Groundwater Transfer Review Summary Form

Transfer/PA # T- 14703

Application: T-14703

Applicant Name: Sunnyside Dairy

T-14703
Sunnyside Dairy

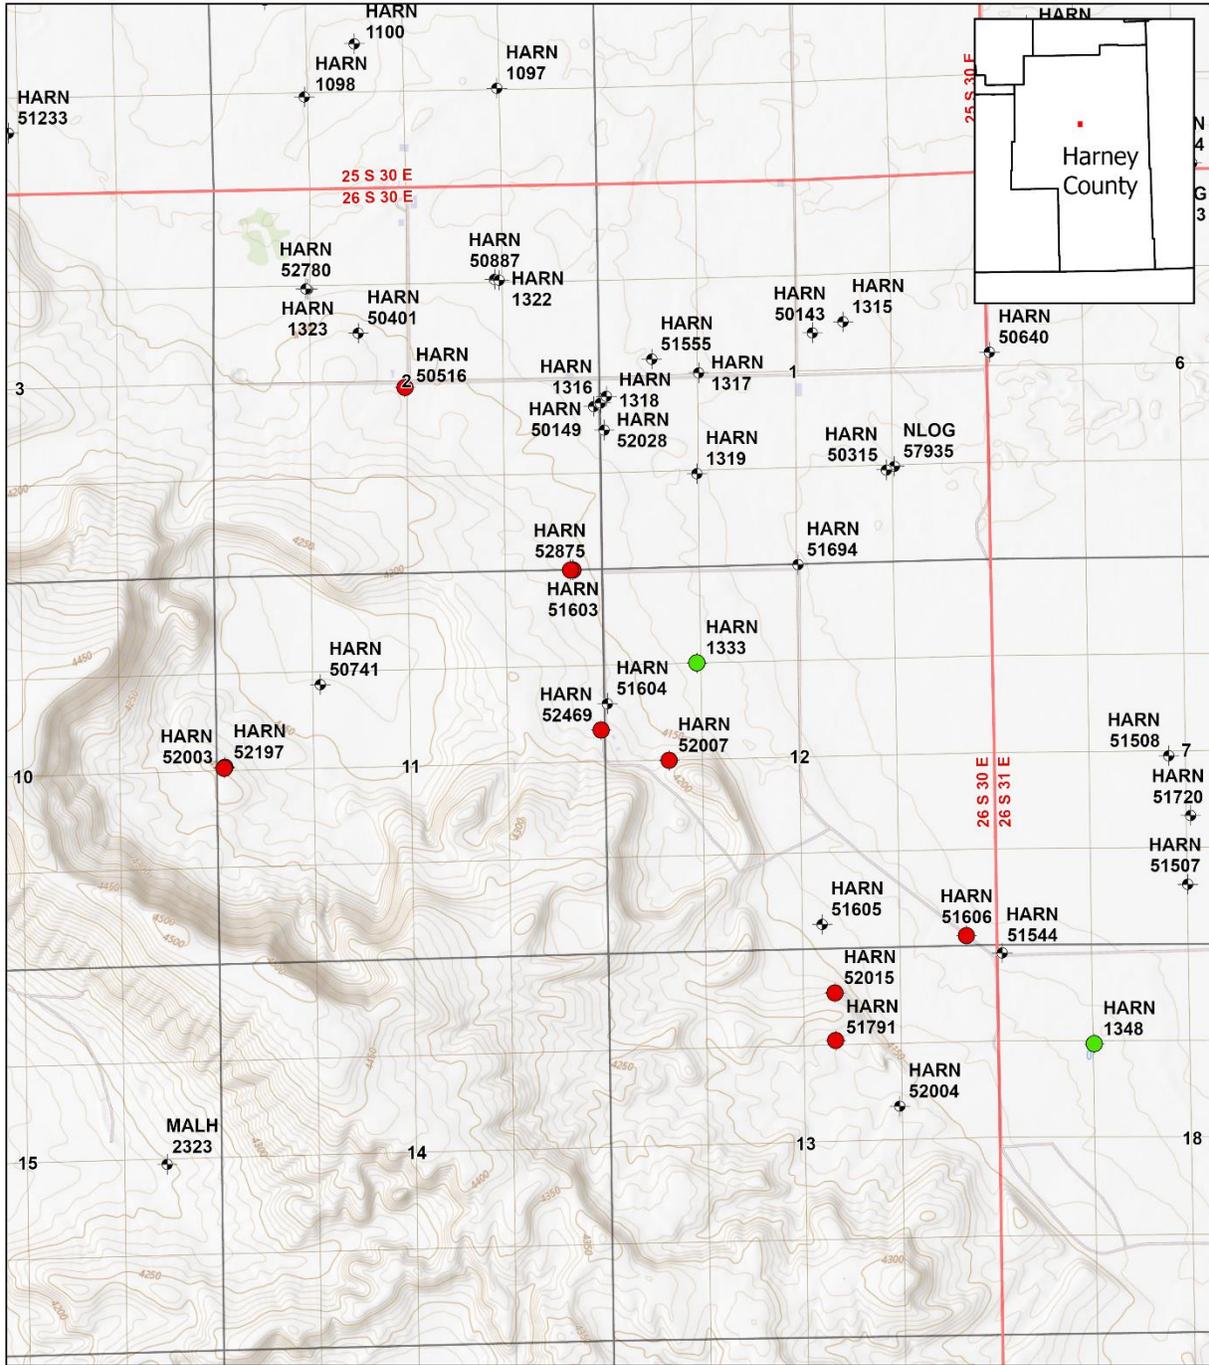
The currently authorized POA and the proposed wells are all located within ~2.5 miles in the Weaver Springs area and are located along groundwater flow paths receiving recharge from a similar source.

The proposed APOA are located up to ~2.5 miles from the currently authorized wells in several directions. This will result in an incremental increase in interference with wells in those areas.

There are no perennial surface water sources in the vicinity of the authorized or proposed wells.
